### CITY OF ALLENTOWN

R92 - 2020

# **Certificates of Appropriateness for work in the Historic Districts:**

# HISTORIC ARCHITECTURAL REVIEW BOARD CITY OF ALLENTOWN, PENNSYLVANIA July 6, 2020

Address: 235-237 N 11th Street

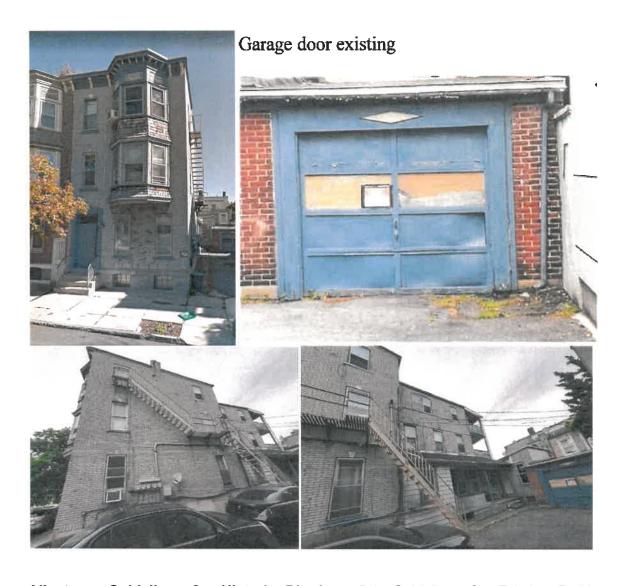
**Evaluation, effect on historic district, recommendations**: The proposed renovations are historically appropriate and meet the design guidelines. Areas to discuss or for which the applicant has requested HARB recommendations include:

- The front steps it is recommended to replace the existing concrete steps with new concrete steps with bull nose detail to match existing or to replace with brick steps with bluestone treads.

- Front door and sidelight this entry was originally a pair of doors. The existing door is a 36" +/- modern door with narrow sidelight and original transom overhead. It is recommended to eliminate the narrow sidelight, widen the side trim at the door to create small pilasters, and install an historically appropriate door, possibly with half or ¼ light.

- Garage door of garage on 235 lot the garage door faces towards 11<sup>th</sup> street but is set back significantly. The proposal is to replace the deteriorated 8 panel and glass door with a solid flush door may be historically appropriate since it is set so far back from the street. Another option to consider would be a steel 16-panel door.

- Light fixture at entry specification should be submitted and approved by staff.

- 1. The proposal to do façade renovations at 235-237 N 11th Street was represented by Peter Lewnes.
- 2. Brickote on the front will be carefully removed from the brick to limit damage as much as possible

- 3. The brick will be cleaned, repaired, and replaced where necessary using historically appropriate mortar
- 4. The brickote on the side of the building will be either removed or stain or painted.

- 5. The rotted wood shingles on the bay window will be replaced in kind or repaired as necessary. When shingles removed a site visit should be scheduled with the City to see if historic materials remain that might be restored.

- 6. Existing front vinyl windows (10) will be replaced with aluminum clad wood 1 over 1 Harvey windows
- 7. Existing vinyl windows on the side of the building (17) will be replaced with new beige vinyl 1 over 1 windows (Note: fire rated windows may be required within 10' of the existing fire escape)

- 8. The front steps will be replaced with concrete steps with bullnose edges. The iron railings will be reused.
- 9. The house numbers will be in gold leaf in the transom above the front door.

- 10. The new light fixture specifications (including lighting along the side of the building) will be submitted to the City for staff approval
- 11. The existing garage door will be replaced with a new flush garage door in a dark color.

- 12. The side porch floor decking with be replaced in-kind with tongue and groove decking.
- 13. All woodwork will be repaired or replaced in kind and scraped and painted

- 14. The fire escape and all other iron work will be repaired, prepped, and painted
- 15. If the front door and entry modified in the future, drawings will be submitted for review. It is recommended to eliminate the narrow side light and enlarge the trim on either side and detail as traditional pilasters with simple base and capital.

- 16. The existing satellite dish will be removed.
